February 25, 2016

Number Nine Wind Farm
Response to Peer Review Comments & Revised Sound Level Predictions

**COMMONWEALTH ASSOCIATES, INC.
AUDIBLE NOISE SOUND LEVEL
NUMBER NINE WIND FARM
345 kV GENERATOR LEAD LINE**

Figure 1. Excerpt from Sound Prediction Model with additional Receptor C1A

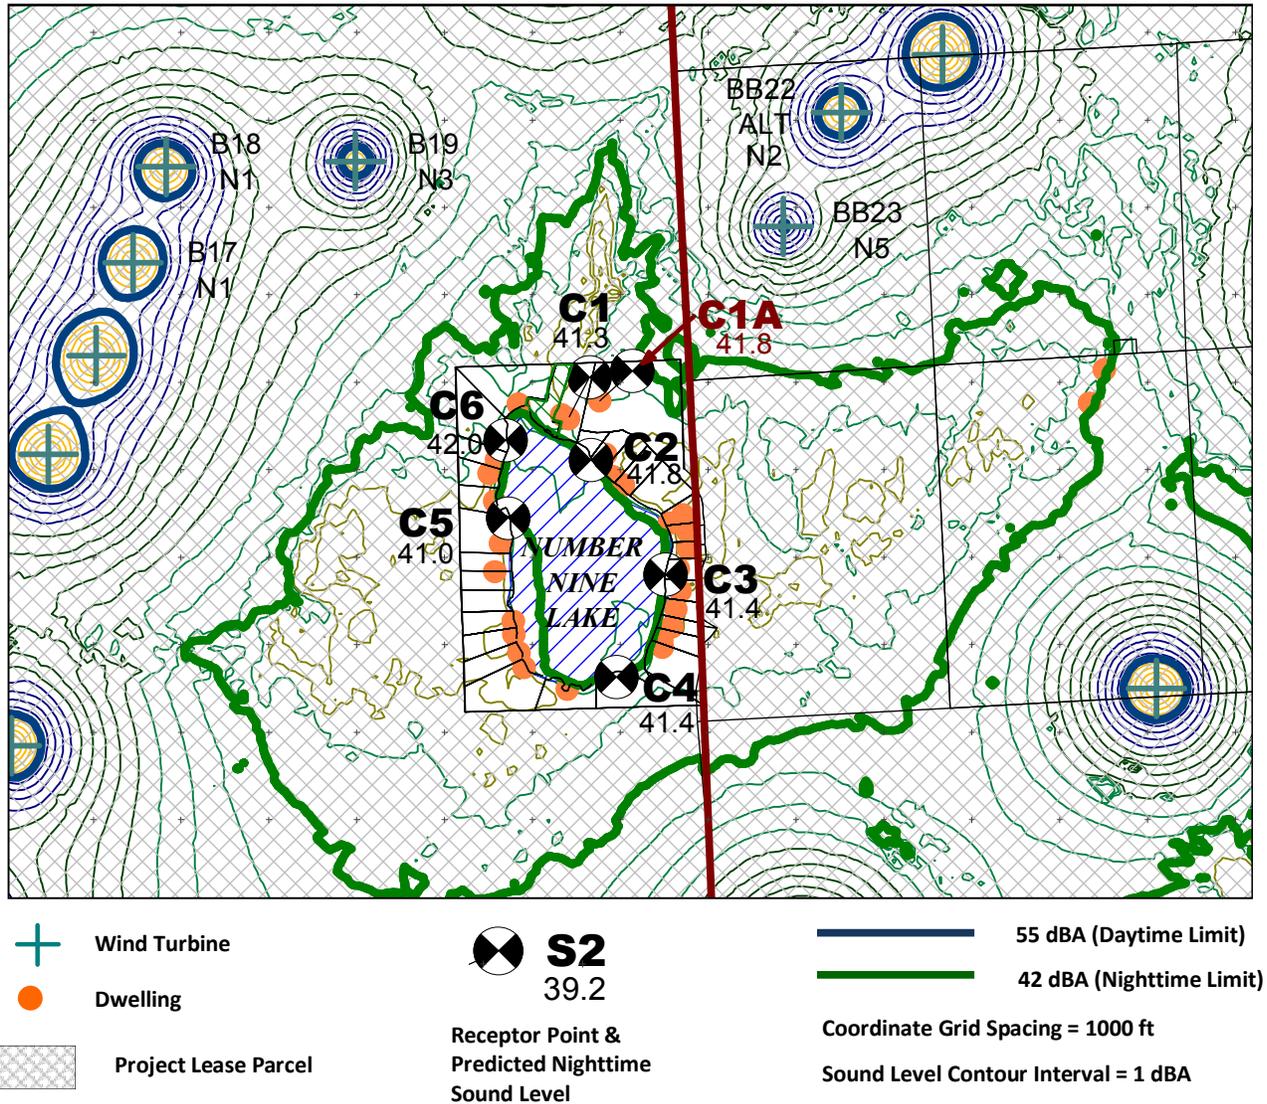
Sound Test Locations – Section 7.0 Sound Level Testing of the BEA Sound Level Assessment states that prior to operation of Number Nine Wind Farm, an operations sound testing plan will be prepared to identify sound test locations. BEA identified receptor points C1 and C6 for the sound test locations to represent receptor points where the predictive model shows that sound levels have the most potential to exceed the applicable sound limits. Tech Environmental recommended “that the second sound test location be receptor C3 across the lake from C6, and not C1, which is relatively close to C6.”

In reviewing these comments in relation to the predictive sound model and test locations, BEA found that receptor point C1 should be moved east approximately 480 feet to represent the specific point within 500 feet of the dwelling on the nearby protected location with the highest potential to exceed the nighttime sound limit. The attached Figure 1 presents an excerpt from the predictive sound model that adds receptor point C1A on this protected location and where the predicted nighttime sound level is 41.8 dBA. The predicted nighttime sound level at this additional receptor point and all other receptor points as identified in the April 2015 Sound Level Assessment are within the 42 dBA nighttime limit. Therefore, this additional receptor point does not affect the report findings regarding compliance demonstration or the nighttime noise-reduced operating (NRO) plan.

Prior to commencing full operations, the sound test locations will be selected based on site conditions to represent those receptor points with the highest potential to exceed the nighttime sound limit. As shown by Figure 1, those would be receptor points C6 and C2, and the additional receptor C1A. When construction of the Project is substantially complete, a detailed site review will be conducted to select and document sound test locations, including sites for one or more 10-meter wind sensors, to represent these receptor points following criteria set forth by Section I(8) of Maine DEP Chapter 375.10. In many cases, proxy locations are selected from site reviews in order to select the best available test locations to represent the receptor points. The selected test locations will be documented as part of an Operations Sound Testing Plan and submitted to the Maine DEP for approval.
